Anan Observatory Replacement

Conceptual Design March 2018

What we've heard so far......

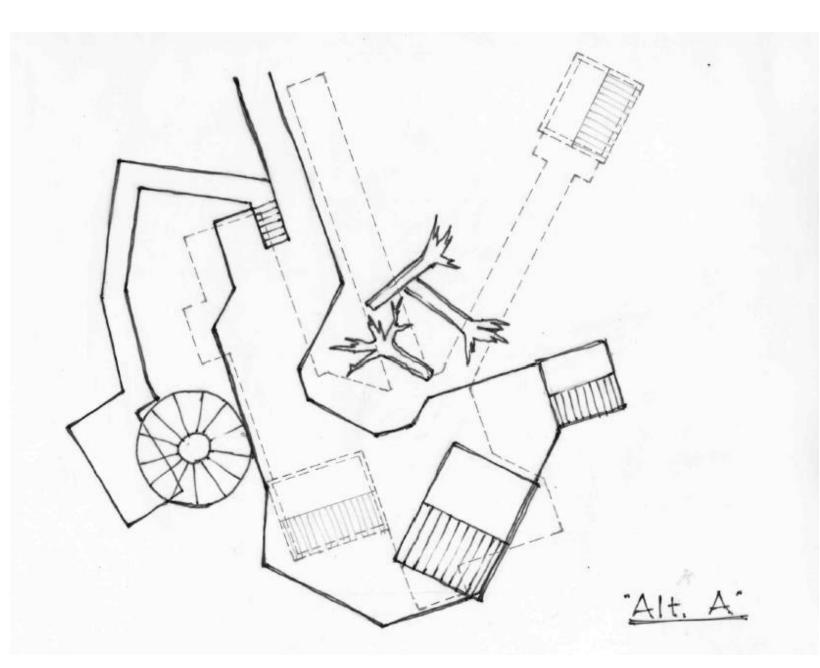
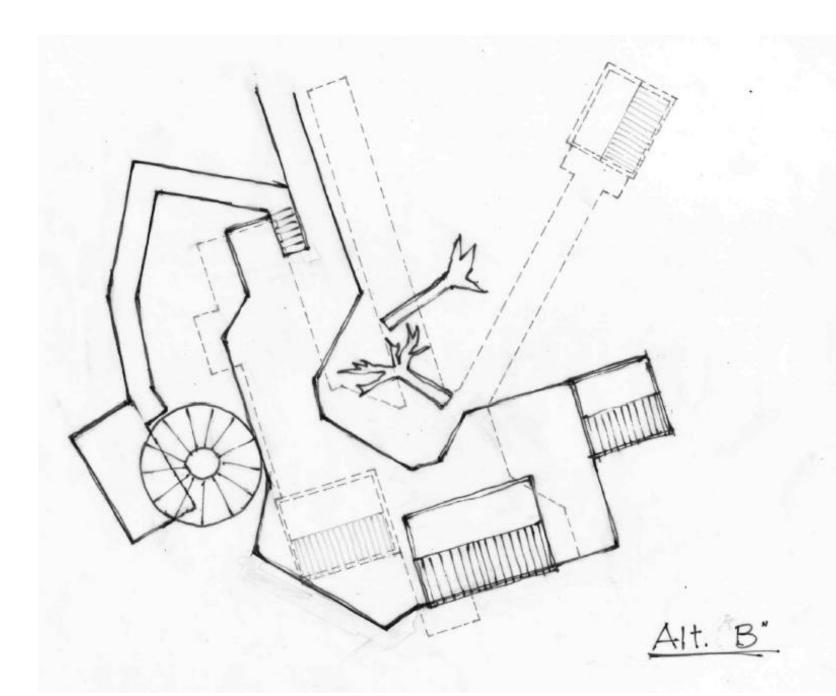
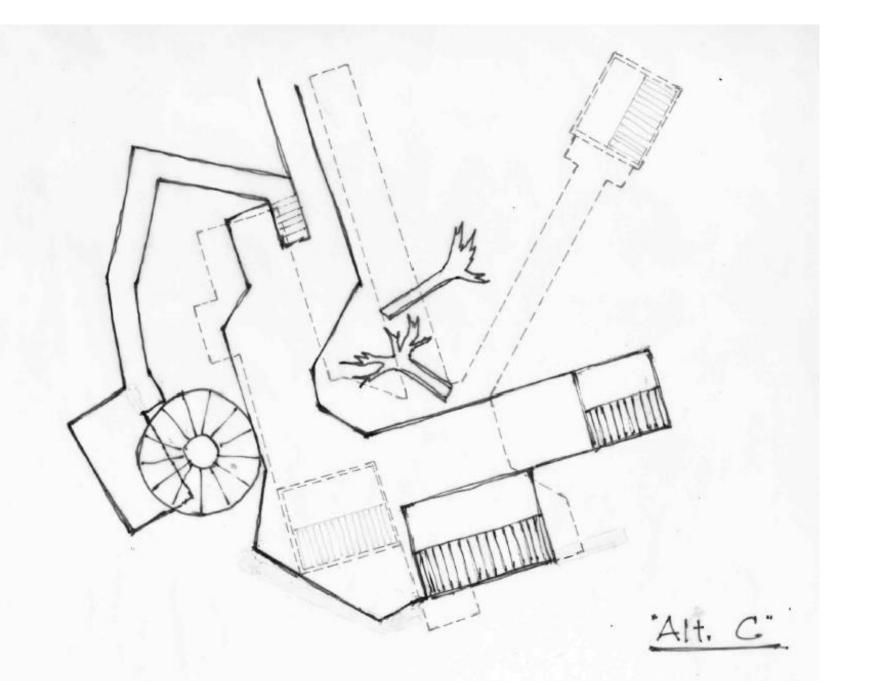
I'm concerned that the new outhouse location will block the trail frequently used by bears coming up the slope from the back eddy fishing location...Bears coming up or down provide some great photographic opportunities.

- An open shelter is great, except for those 50 degree days with wind and rain
- The shelter location may block upstream views, can it be located away from the prime viewing rails?
- ❖ I don't have a problem with the shelter taking up some viewing rail if pointed upstream I find that people do like to sit and contemplate and the upstream view is very conducive to that.

- How will the design accommodate interpretive displays (panels? Signs? Any?)
- The mesh wire will give it more of an open feel.
- The sketches show the stairway and photo blind open without screening. Will they be screened?
